Addendum No. 1
May 11, 2023

JSD Jefferson E.S.

Musgrove Engineering Mechanical Addendum #1 dated 5/11/23, (7) pages, with (36) revised and attached drawing sheets.

Musgrove Engineering Electrical Addendum #1 dated 5/11/23, (3) pages, with (6) revised and attached drawing sheets.

M-3.3

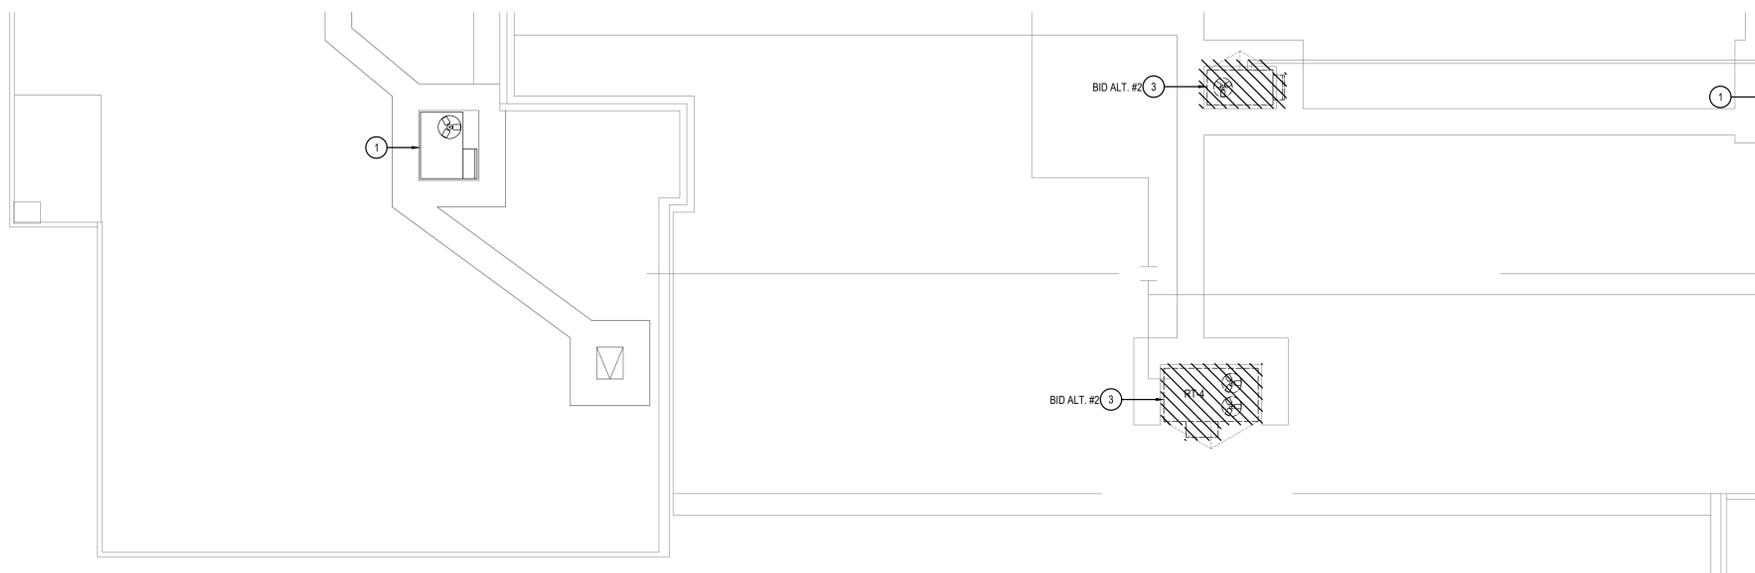
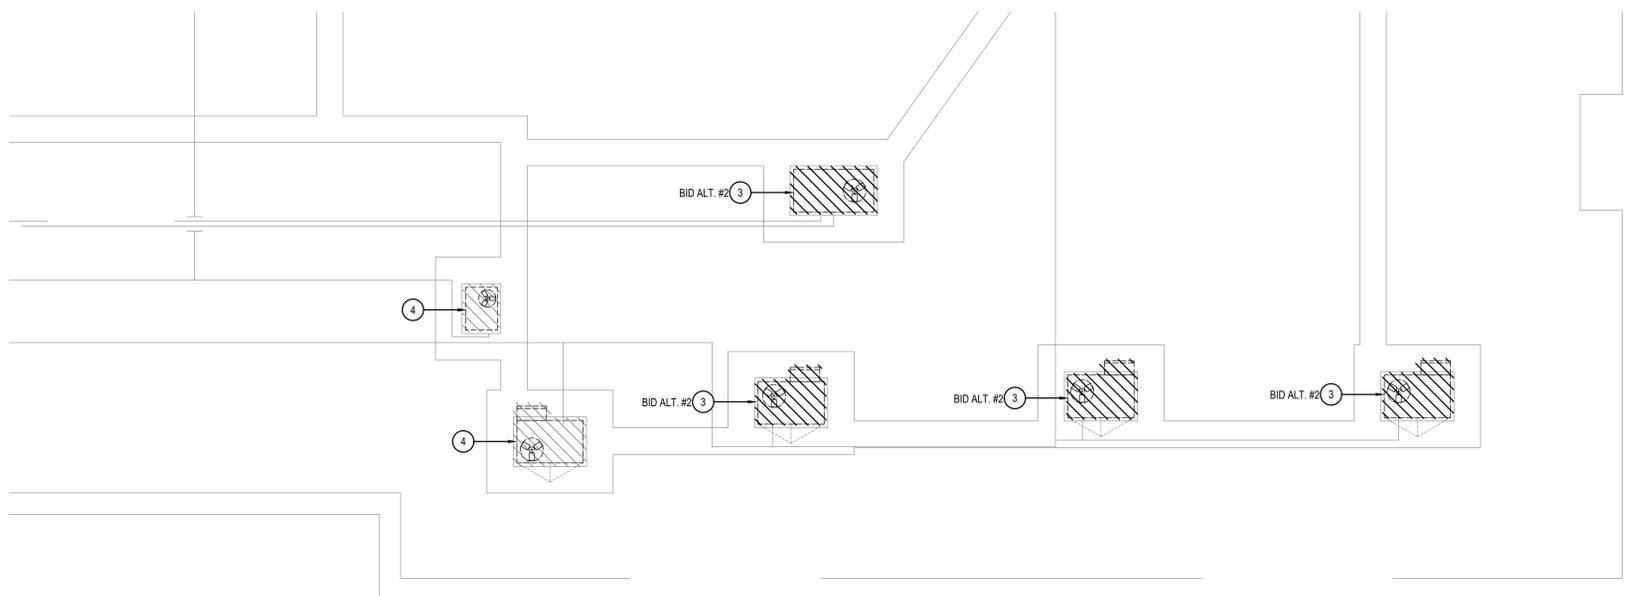
1. Modified keynote 1.
 2. Modified keynote 2.
 3. Modified keynote 3.
- See the Sheet for further information.

M-4.2

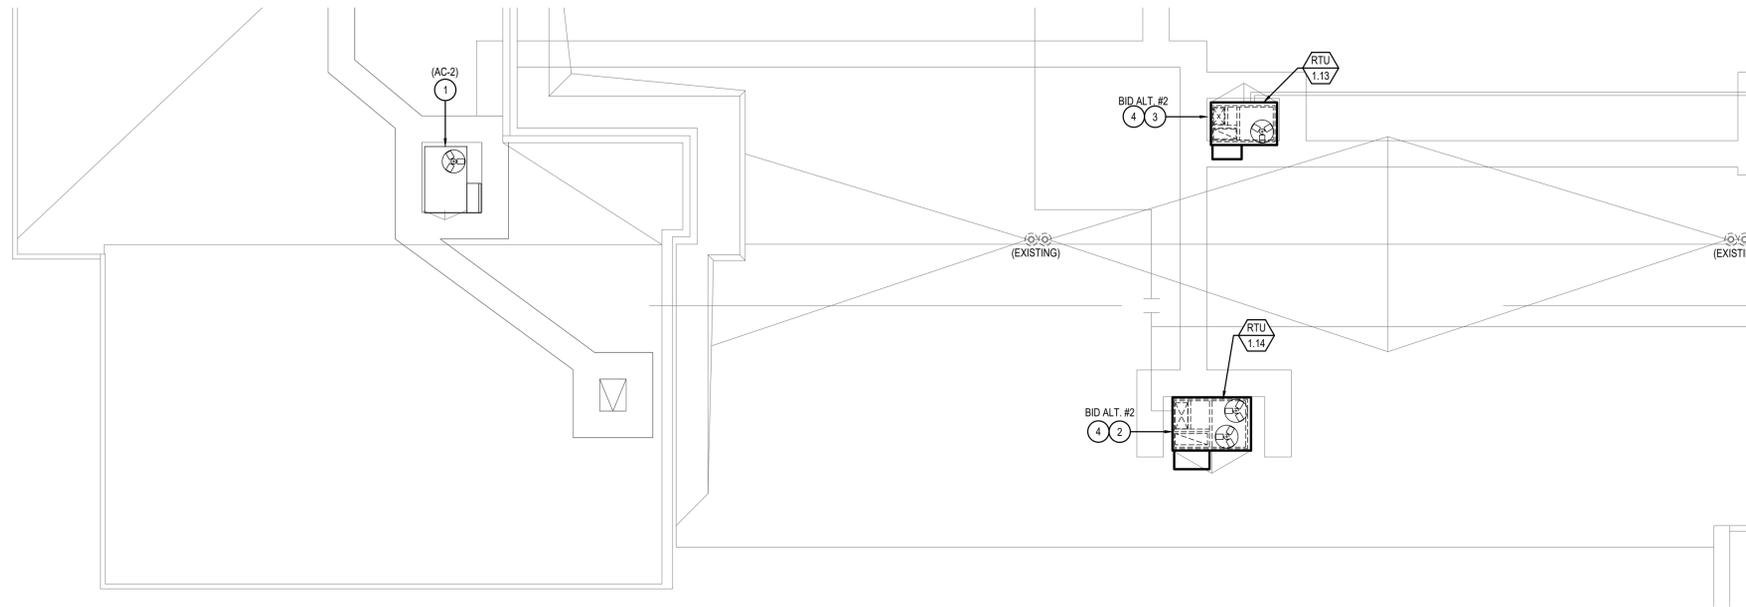
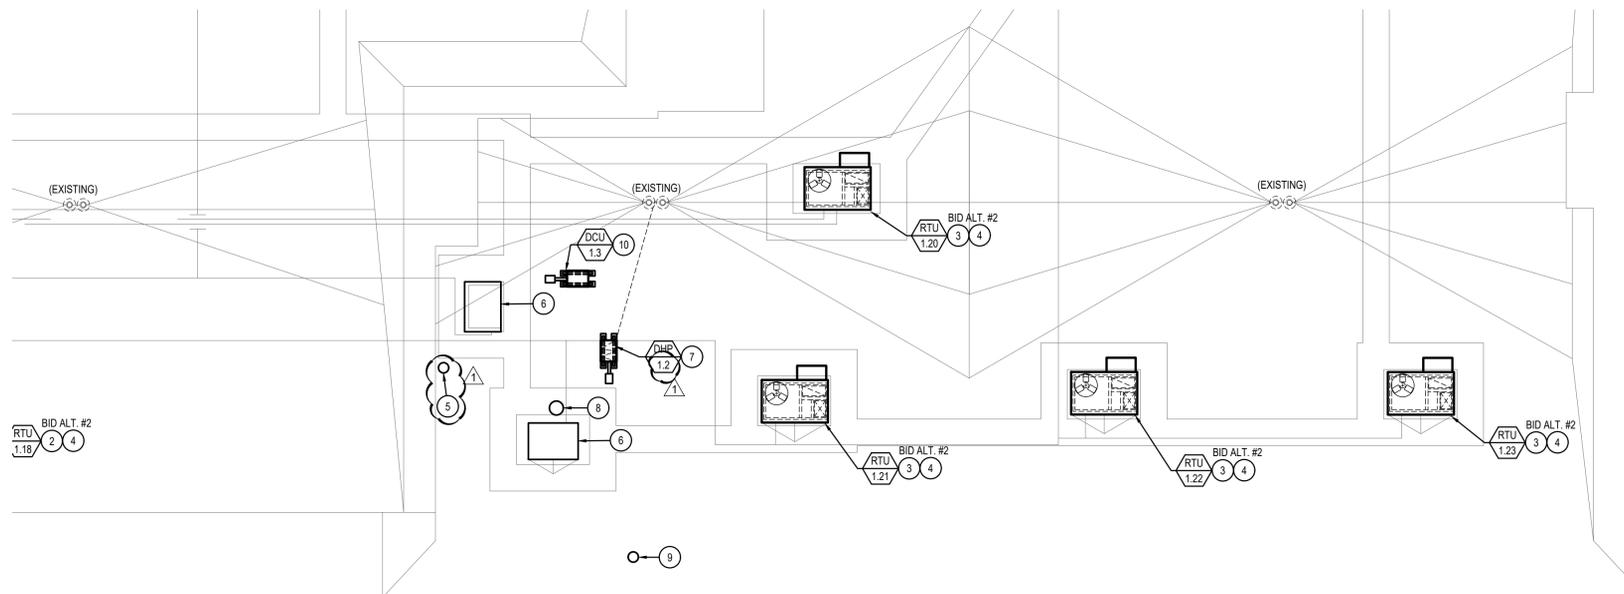
1. Modified keynote 9 and relocated keynote on plan.
2. Added exhaust curb and cap for exhaust duct, keynote 16.
3. Changed EF-1.1 and 1.2 keynotes to 5.
4. Added keynote 17.

2 DESTRATIFICATION FAN DETAIL
NOT TO SCALE

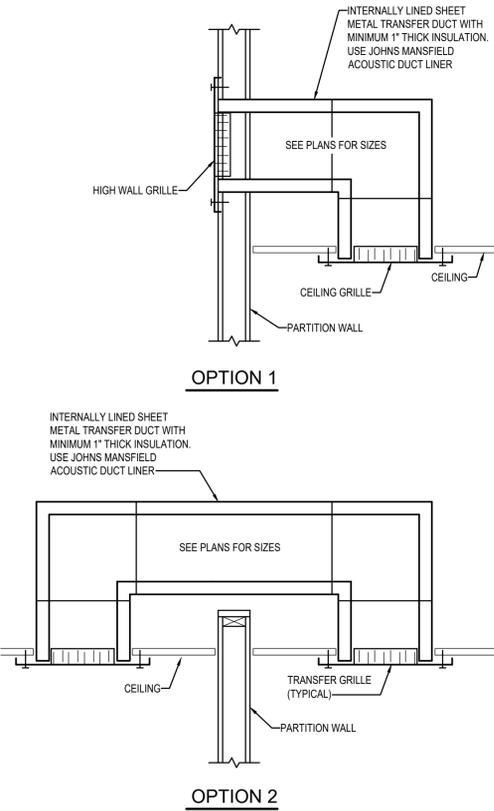
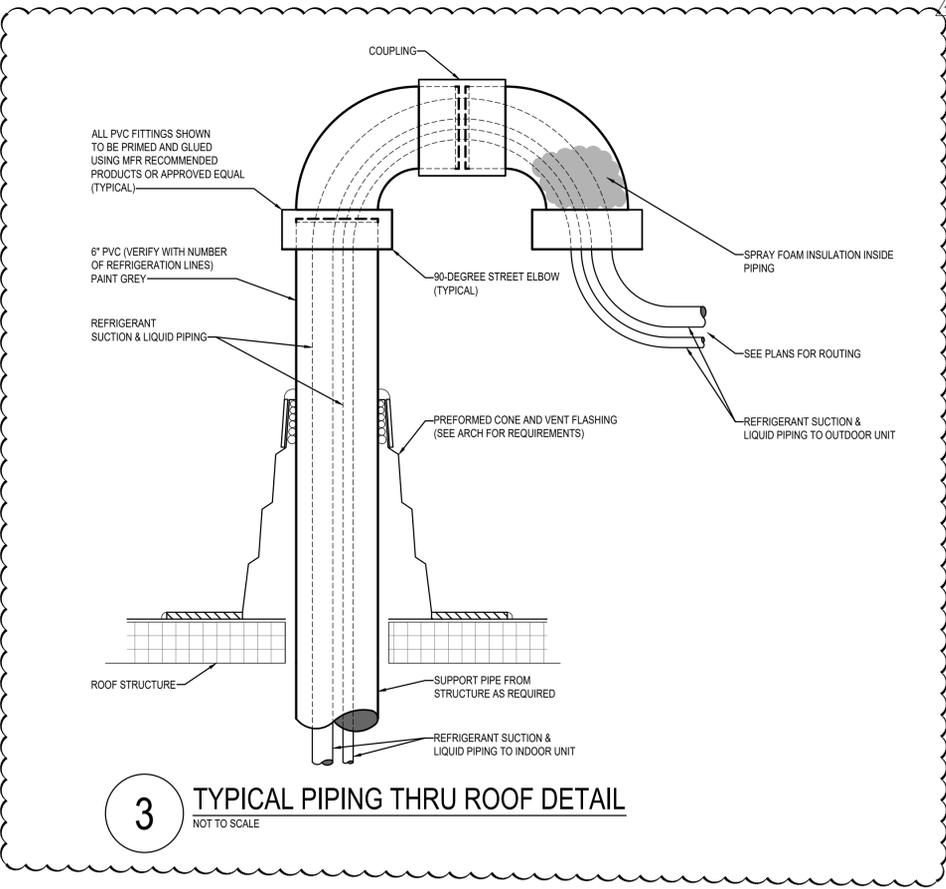
1. Added Piping Through Roof Detail.
2. Added Destratification fan Detail.

1 Plumbing Demolition Plan - Area 'B'
Scale: 1/8" = 1'-0"

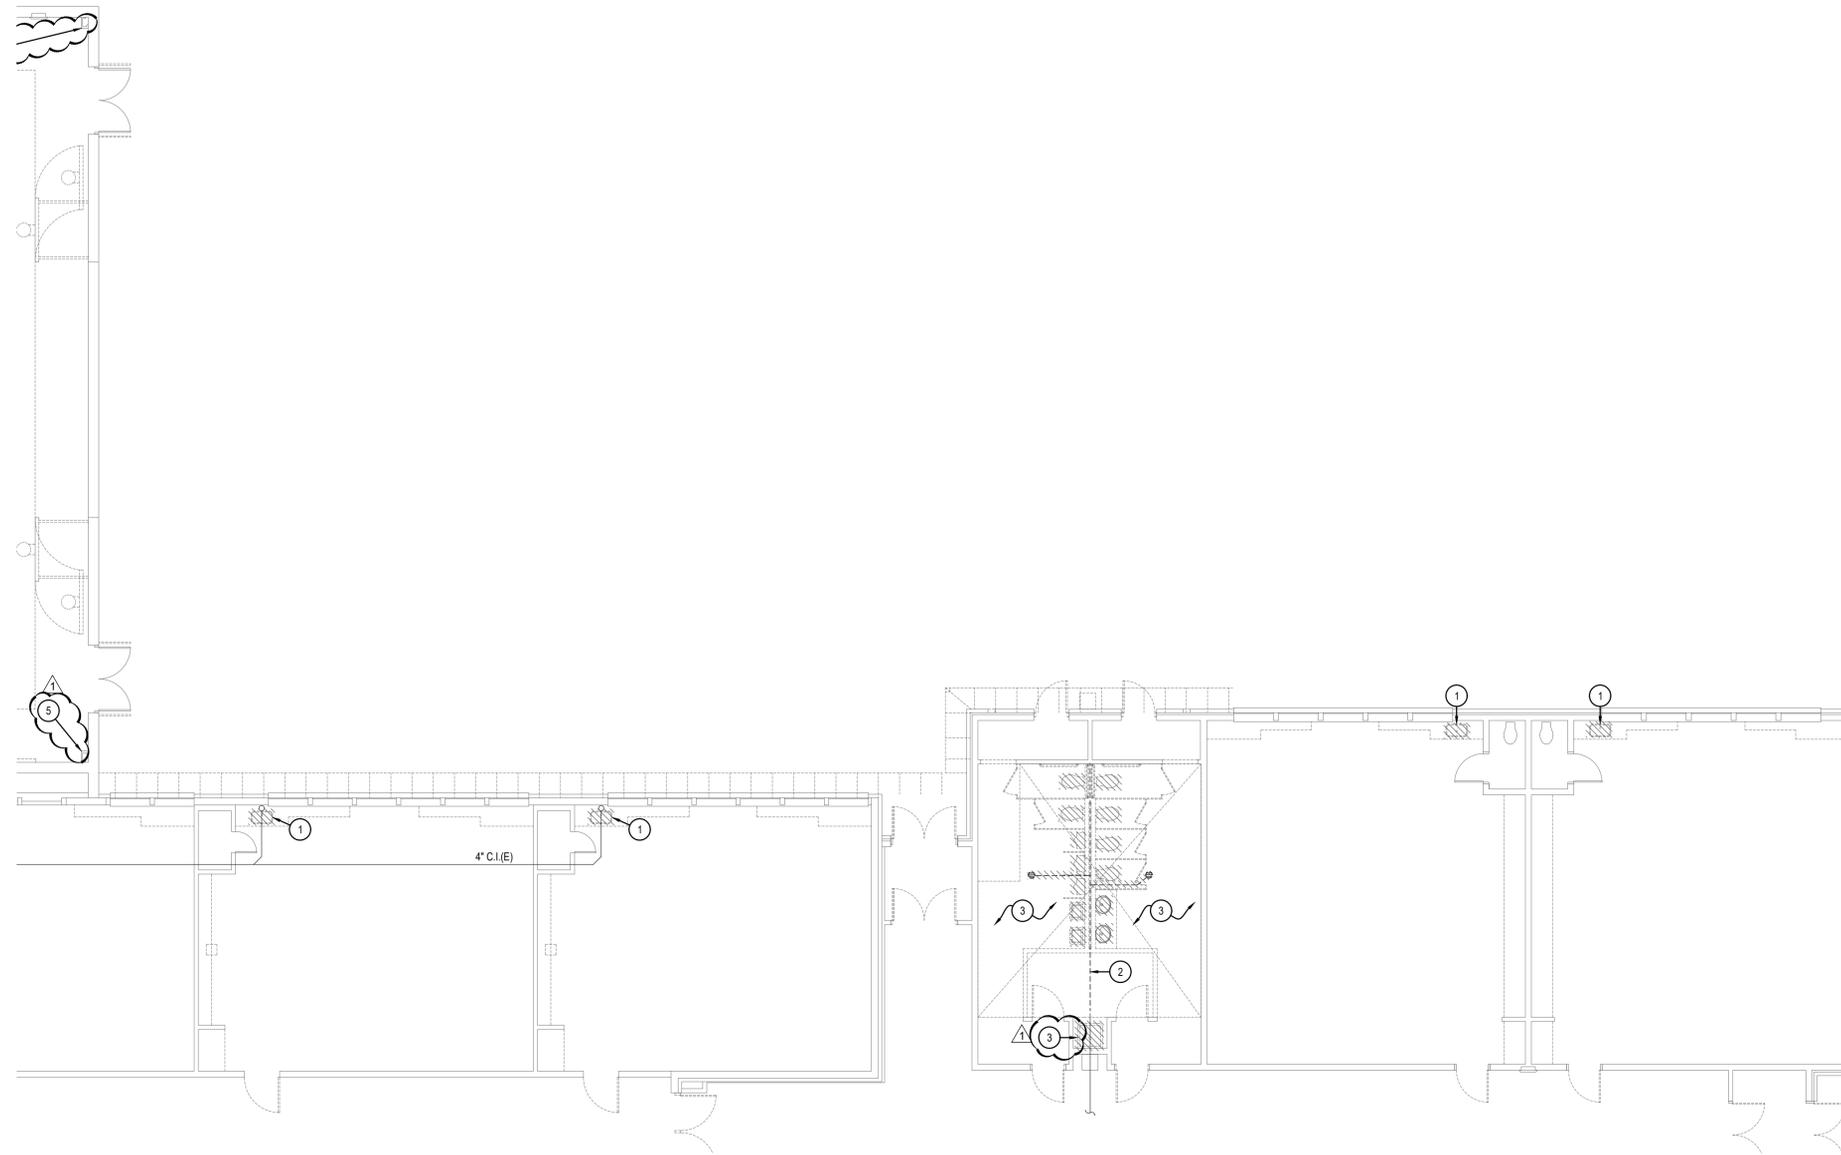
1. Added keynote 5 for removing gym drains.

P-1.3

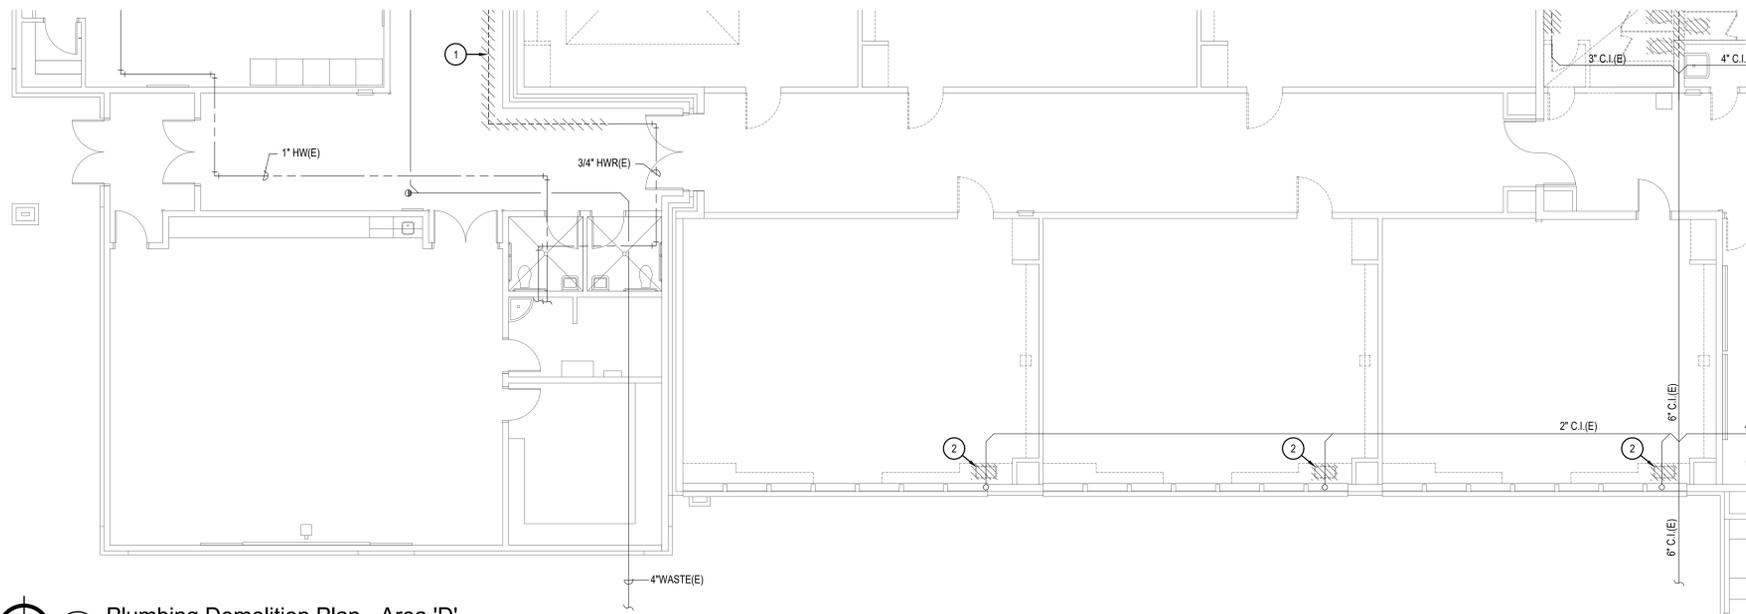
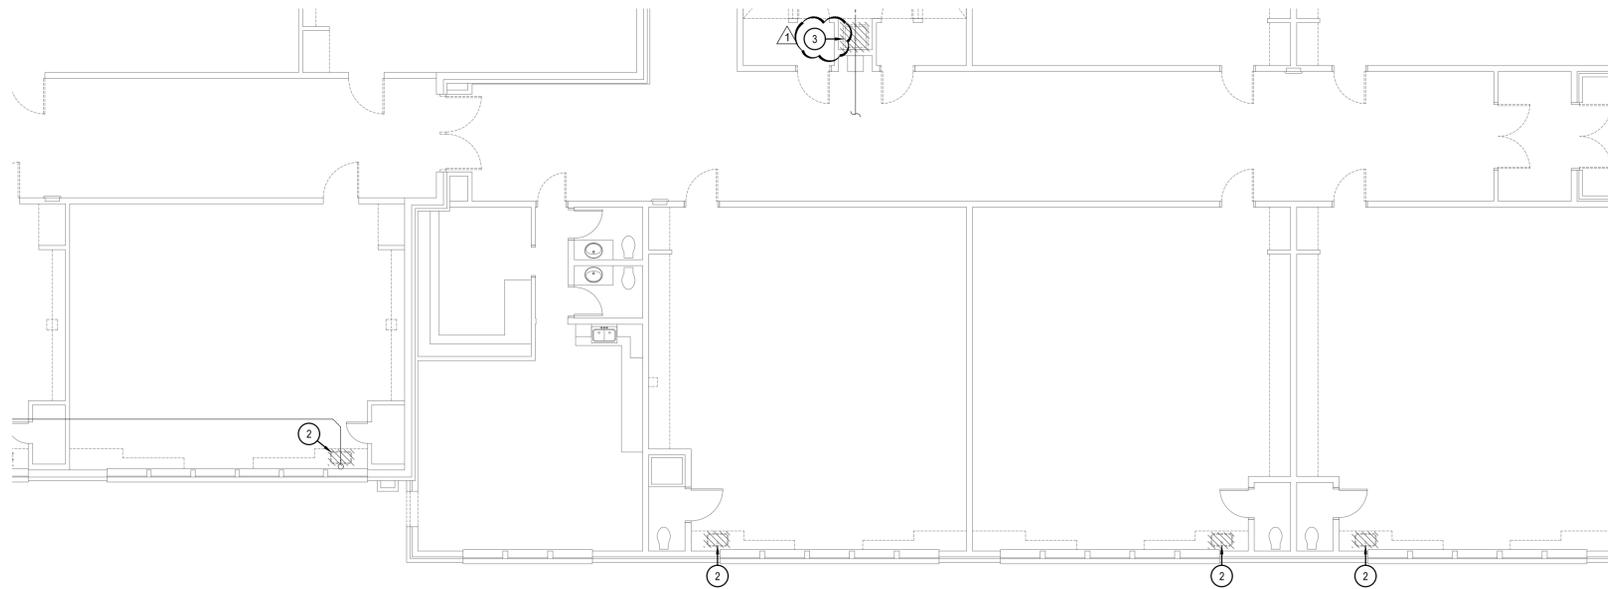
1. Deleted keynote 1, changed plan keynote to 3.

P-2.3

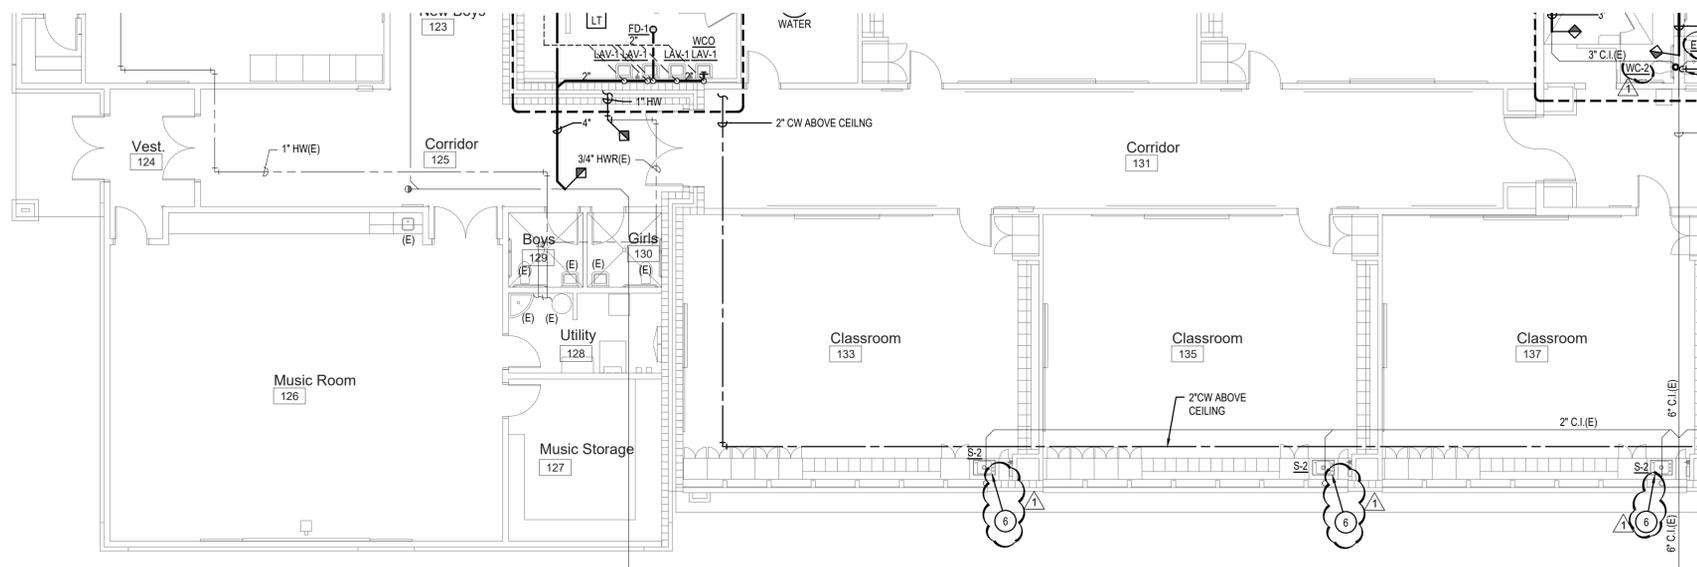
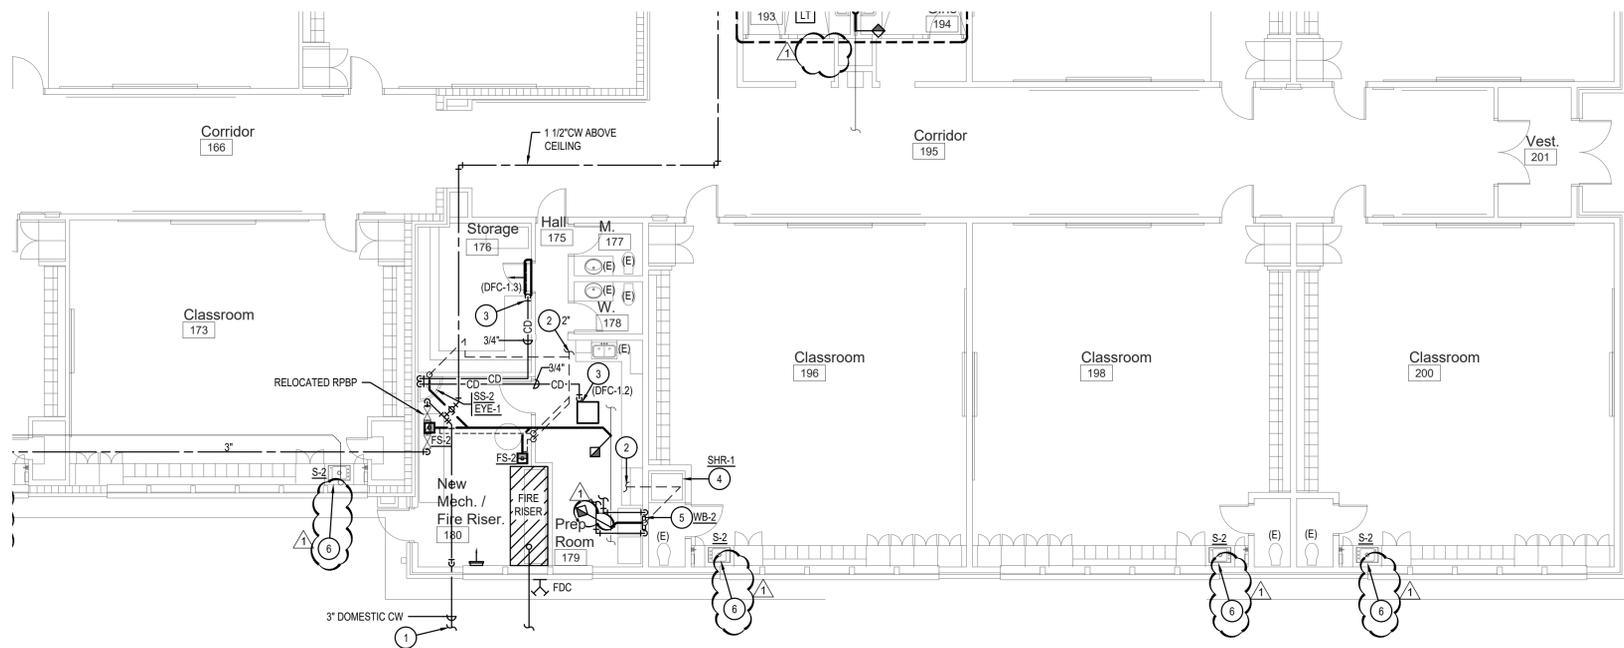
1. Added typical keynote 5 for S-2 sinks.
2. Changed WC-3 to WC-2 in Boys 141
